STATE OF MARYLAND
 WATER RESOURCES ADMINISTRATION
 TOWER STATE OFFICE BLDG., ANNAPOLIS, MARYLAND 21401
 APPLICATION FOR PERMIT TO DRILL WELL

WRA PERMIT NUMBER
 40-713-2524
 FILL IN THIS FORM COMPLETELY

TITLE: LOCATION SURVEY
 PROJECT: LOT 1-CLIFTON CLINK PROPERTY
 LOCATION: 5TH ELECTION DISTRICT-HOWARD Co, MD
 JOB NO.: 8037
 DATE: 1-11-88
 SCALE: 1"=100'
 DRAWN BY: JSH

TITLE: LOCATION SURVEY
 PROJECT: LOT 1-CLIFTON CLINK PROPERTY
 LOCATION: 5TH ELECTION DISTRICT-HOWARD Co MD
 JOB NO.: 8037
 DATE: 1-11-88
 SCALE: 1" = 100'
 DRAWN BY: JPH

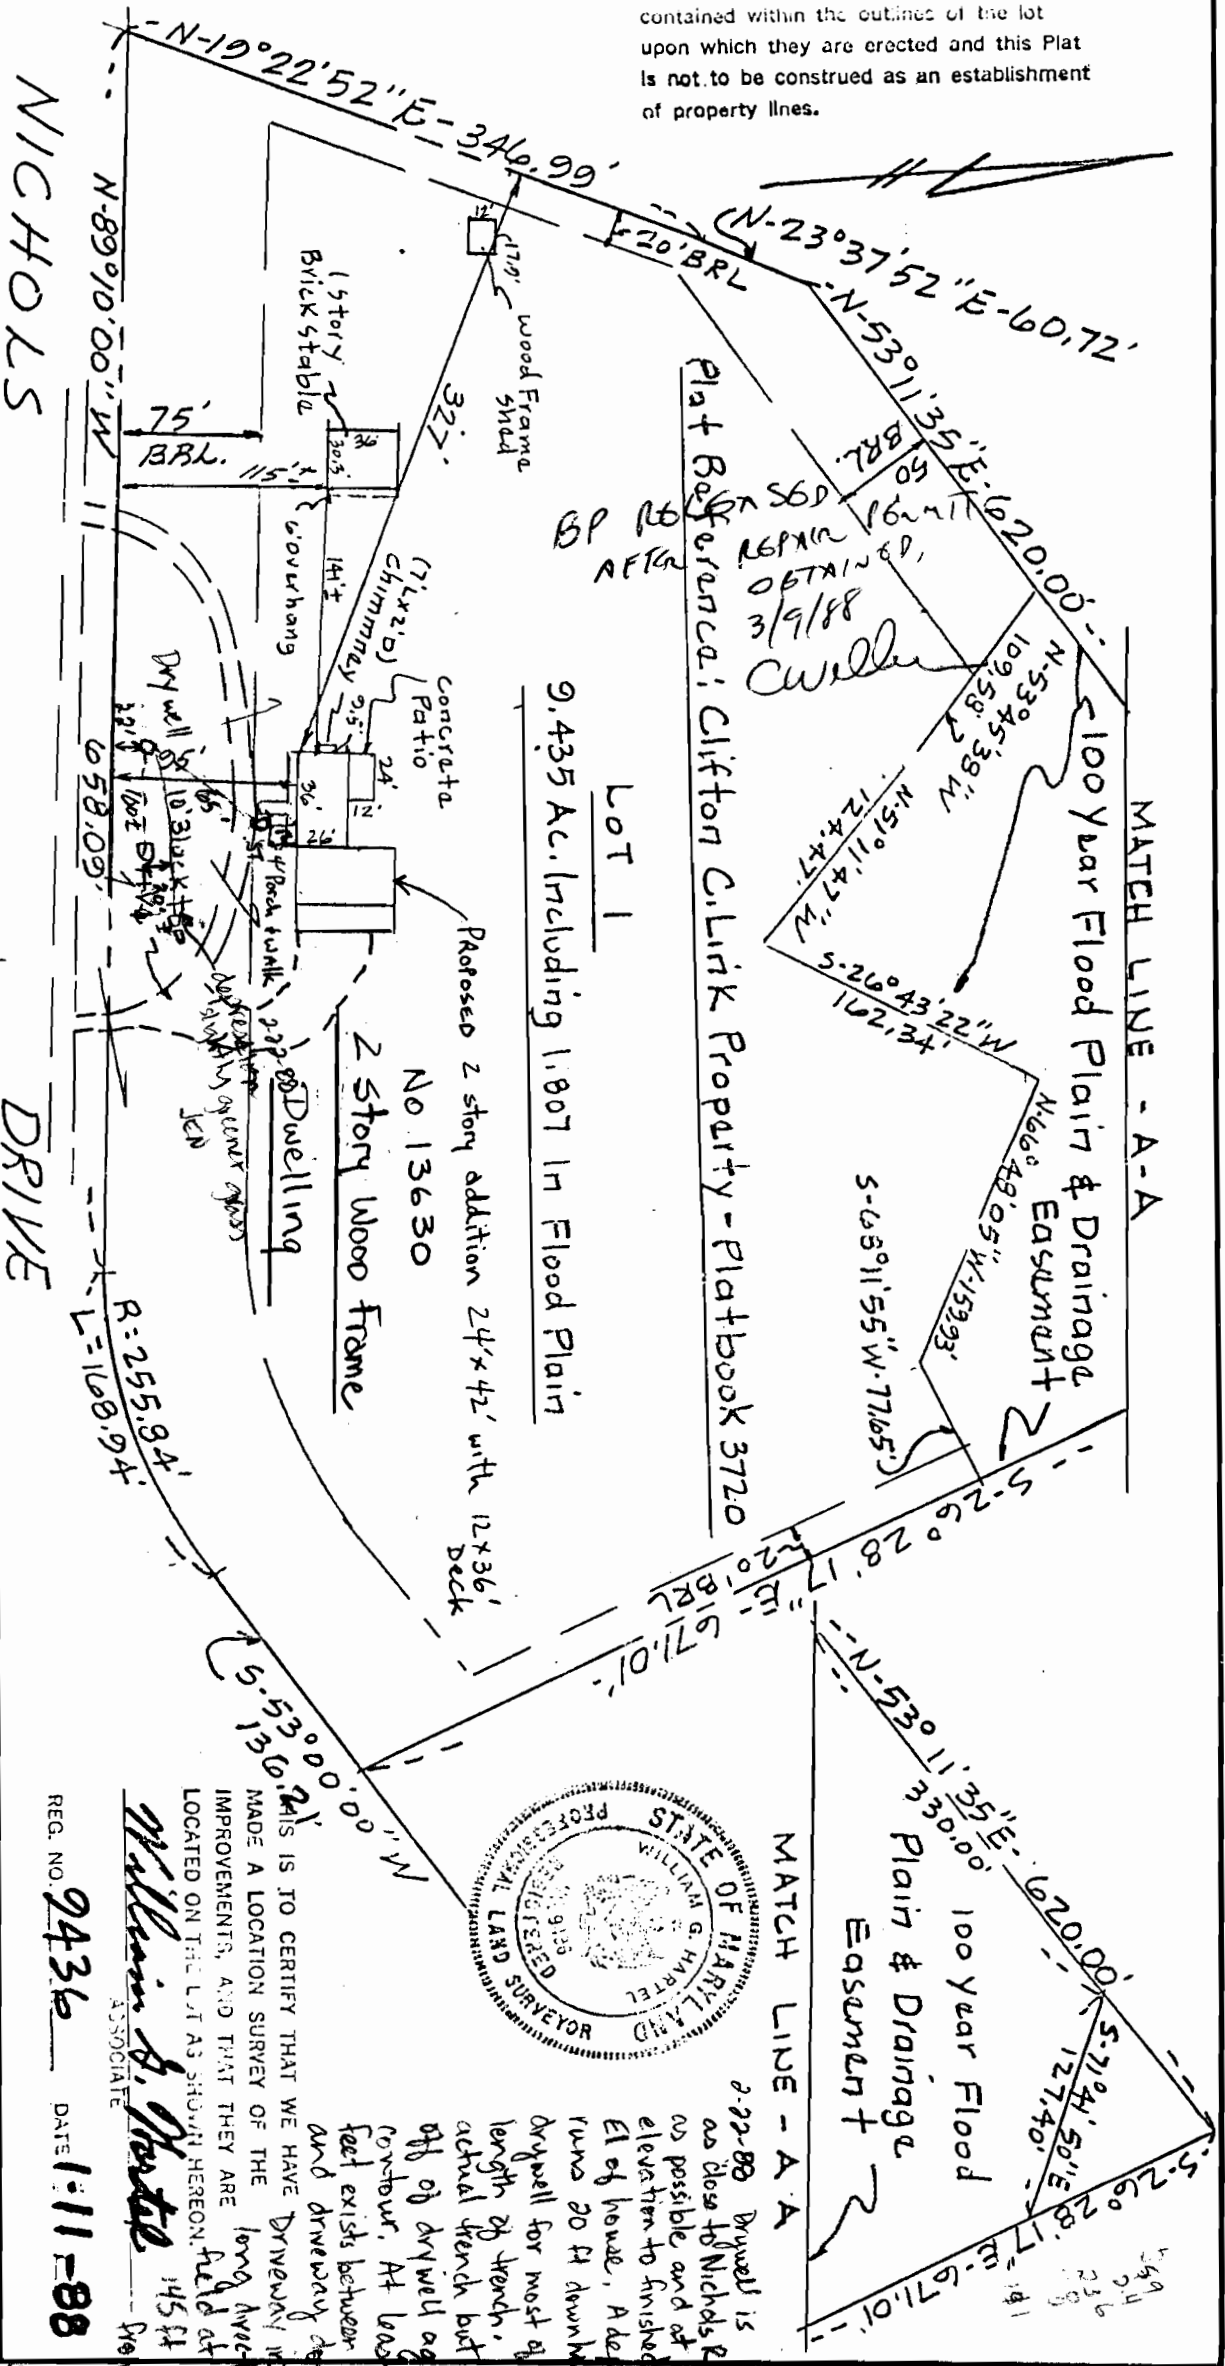
7-22-88 Drivwell is as close to Nichols as possible and of equal elevation to finished floor El of house. A depression runs 20 ft downhill from Drivwell for most of the 91 ft length of trench. May be actual trench but angles off of drivwell against contour. At least 50 feet exists between drivwell and driveway down slope. long driveway intercepts long driveway by about 145 ft down slope from Drivwell. Recommended addition to system for extra bytown JEN.
